PROPOSED TECHNICAL SPECIFICATION REVISIONS
BROWNS FERRY NUCLEAR PLANT
UNITS 1, 2, AND 3
(TVA BFNP TS 191)

ENCLOSURE 2
DESCRIPTION OF PROPOSED CHANGE TO TECHNICAL SPECIFICATIONS FOR
BROWNS FERRY NUCLEAR PLANT UNITS 1, 2, AND 3
(TVA BFNP TS 191)

ENCLOSURE 3
JUSTIFICATION AND SAFETY ANALYSIS
(TVA BFNP TS 191)

Figure 3.6-1

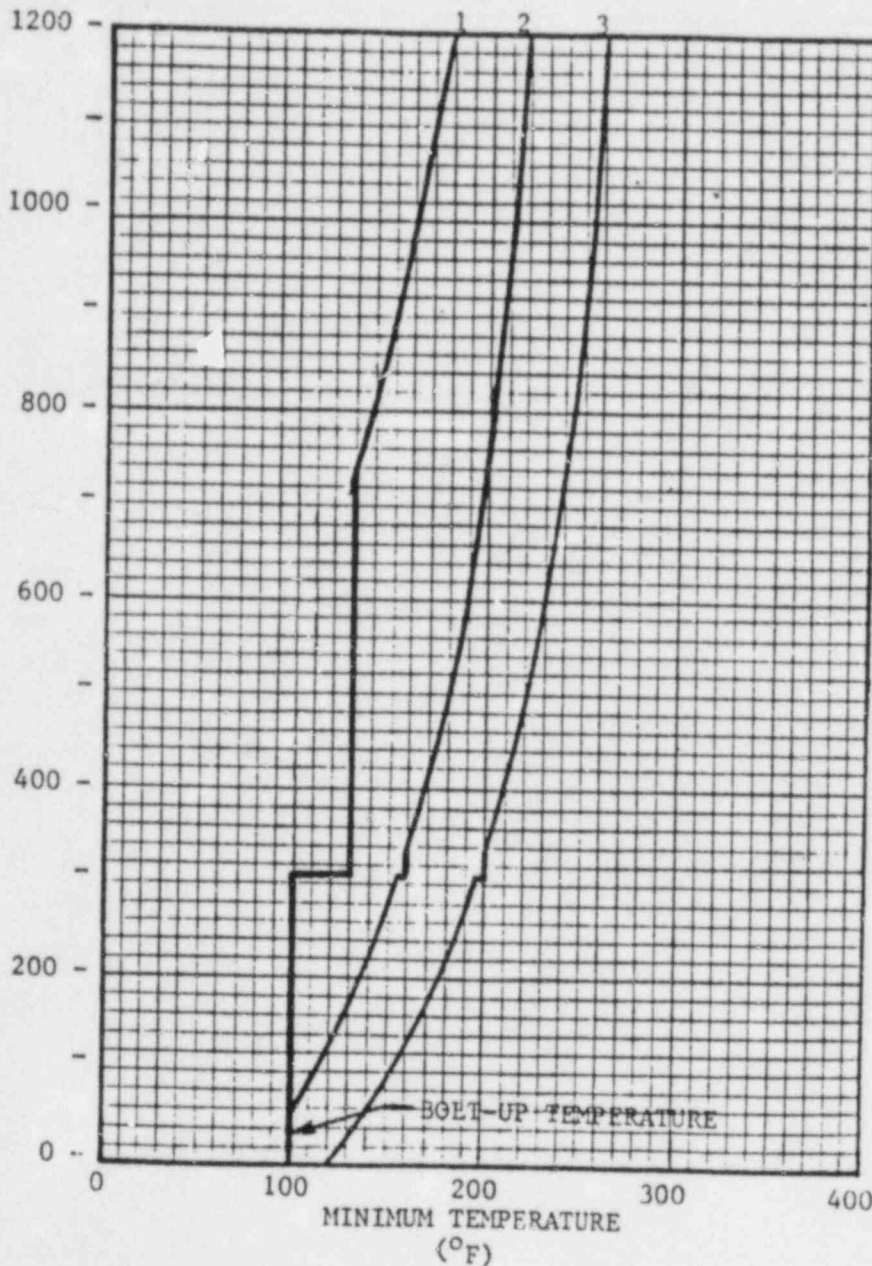
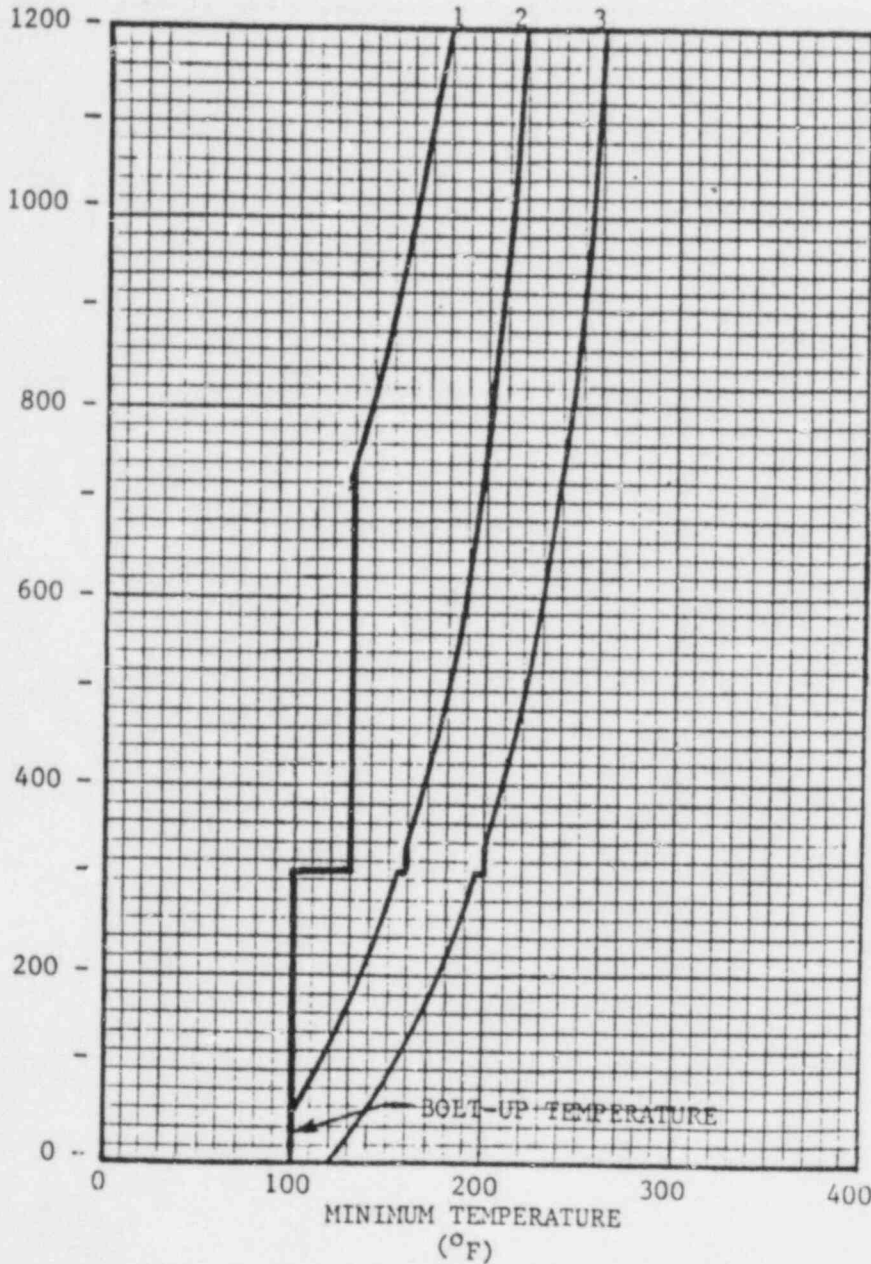
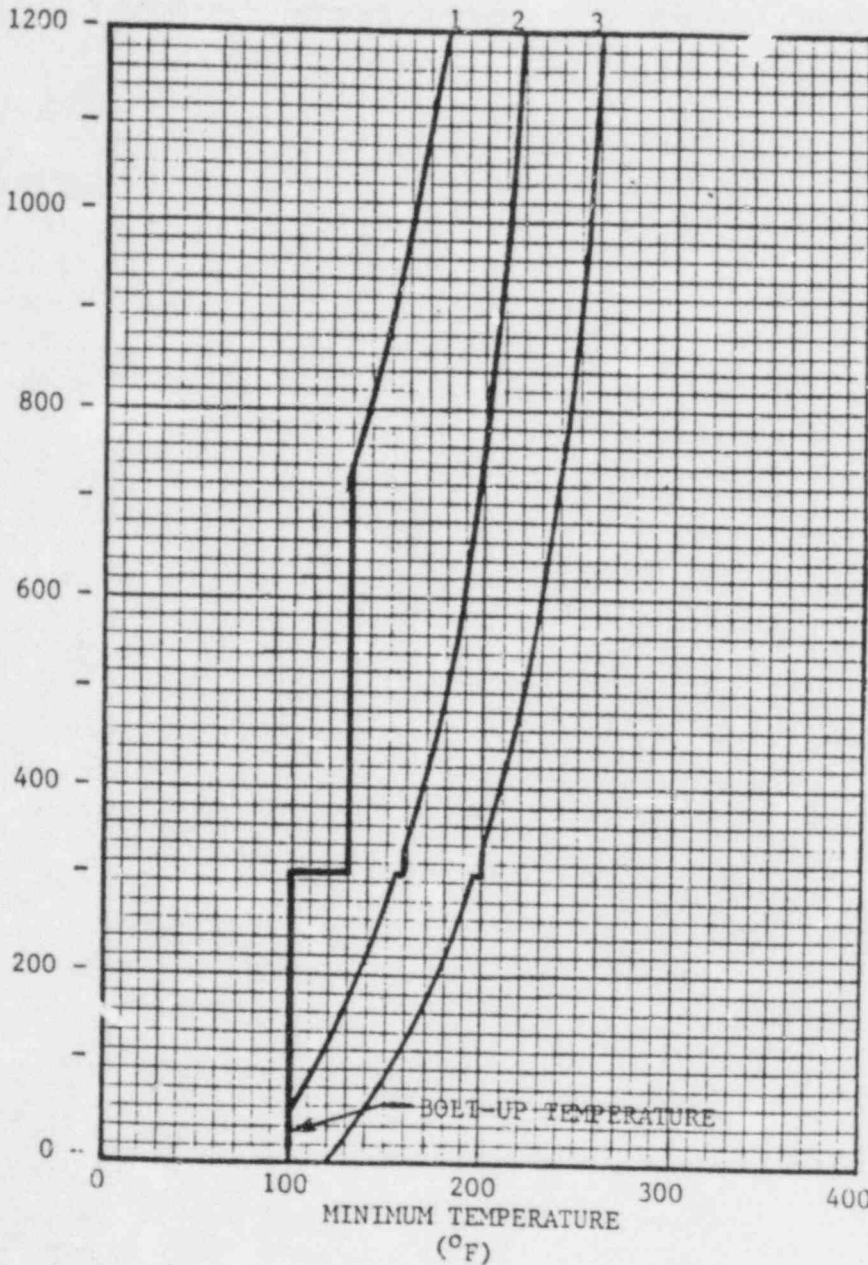
Revise figure 3.6-1 as necessary to reflect more realistic, but conservative, values of beltline material RT_{NDT} based on material analyses and testing.

Reason

The pressure-temperature limit curves which are presently implemented at Browns Ferry Nuclear Plant (BFN) are based on a conservative baseline RT_{NDT} in the vessel beltline region to compensate for embrittlement caused by 6.0 effective full power years (EFPY) of accumulated neutron fluence. Thus, the presently used curves are based on a maximum RT_{NDT} of $40 + 36 = 76^{\circ}\text{F}$ in the vessel beltline region and a maximum RT_{NDT} of 40°F in the vessel closure flange region and the feedwater nozzle.

Combustion Engineering, Inc. (CE), performed material analysis to determine the actual copper content for the limiting vessel beltline materials in units 1, 2, and 3. Examination of the results showed that the maximum copper content is in the unit 2 weld material and is equal to 0.20 percent. Charpy impact testing has been performed at Singleton Materials Engineering Laboratory to determine the baseline RT_{NDT} for the beltline materials in units 1, 2, and 3. The combined end results of the CE analysis and the Singleton testing show that the maximum final RT_{NDT} is in the unit 2 weld material and is equal to 58°F . This value of 58°F is less than the value of 76°F on which the presently used curves are based and therefore provides a basis for relaxing the pressure-temperature limits.

The proposed curves are based on a beltline region 40 EFPY RT_{NDT} of 58°F which is based on actual material testing. The curves also provide relief on minimum temperature for core operation (criticality) as allowed for boiling water reactors by revised 10 CFR 50 appendix G which became effective July 26, 1983. They also include temperature limits as recommended in General Electric Company Service Information Letter 207, November 1979, to protect against further degradation of the feedwater nozzles; therefore, the safety of the plant is not degraded due to the proposed curves.
